Access Compliance Report

Public Rights-of-Way

(Curb Ramps)

Intersection ID: 17205	Main Street: LINDA_LN	Cross Street: WALKER_RD	Location: NW
ADA ID: A5731C91F031	Ramp Type: ParaDiag	Initial Pass/Fail: Fail	Overall Compliance: No
Severity Score: 48.75			
Codes/Mitigation Info/Possible Solution		Field Measurements/Component Compliance

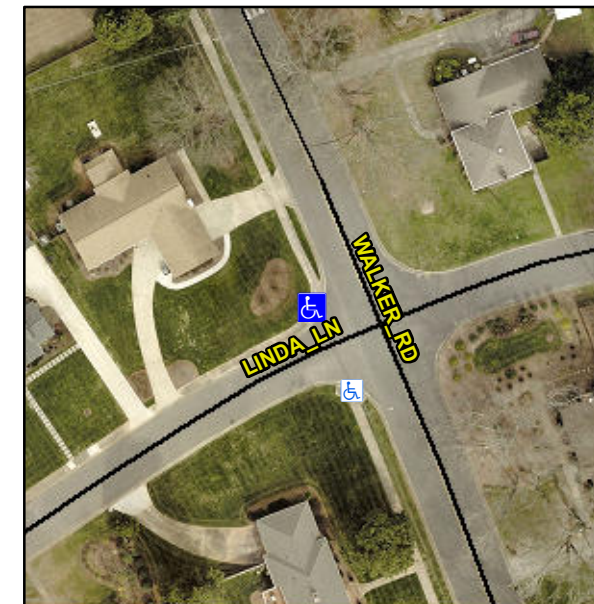
LT RP < 5%

R304.5.1, R304.5.3, R304.3.2

Compliance	Description	Data	Compliance	Description	Data
N/A	Ramp Length LT (in)	59.0	N/A	Ramp Length RT (in)	63.0
No	Ramp Width LT (in)	30.0	No	Ramp Width RT (in)	34.0
Yes	Ramp Slope LT (%)	2.3	No	Ramp Slope RT (%)	8.5
No	Ramp XSlope LT (%)	2.7	Yes	Ramp XSlope RT (%)	1.9
N/A	Landing Length (in)	N/A	N/A	DWS Provided?	N/A
N/A	Landing Width (in)	N/A	N/A	DWS Contrast?	N/A
N/A	Landing Slope (%)	N/A	N/A	DWS Length (in)	N/A
N/A	Landing X Slope (%)	N/A	N/A	DWS Full Width?	N/A
N/A	Landing Curb? (Y/N)	N/A	N/A	DWS Offset (in)	N/A
N/A	Shared Landing?	N/A			
N/A	Gutter Ponding?	N/A	N/A	Gutter Slope (%)	N/A
N/A	Gutter Lip Ht (in)	N/A	N/A	Gutter X Slope (%)	N/A
N/A	Painted X Walk1?	No	N/A	Painted X Walk2?	No
	X Walk 1 Direction	To SE		X Walk 2 Direction	To NE
N/A	X Walk 1 Width (in)	N/A	N/A	X Walk 2 Width (in)	N/A
	X Walk 1 Slope (%)	1.1		X Walk 2 Slope (%)	1.8
	X Walk 1 X Slope (%)	1.8		X Walk 2 X Slope (%)	0.8
N/A	Ramp inside XWalk1?	N/A	N/A	Ramp inside XWalk2?	N/A

Remove & Replace Curb Ramp With Two New Directional Ramps or Equivalent.
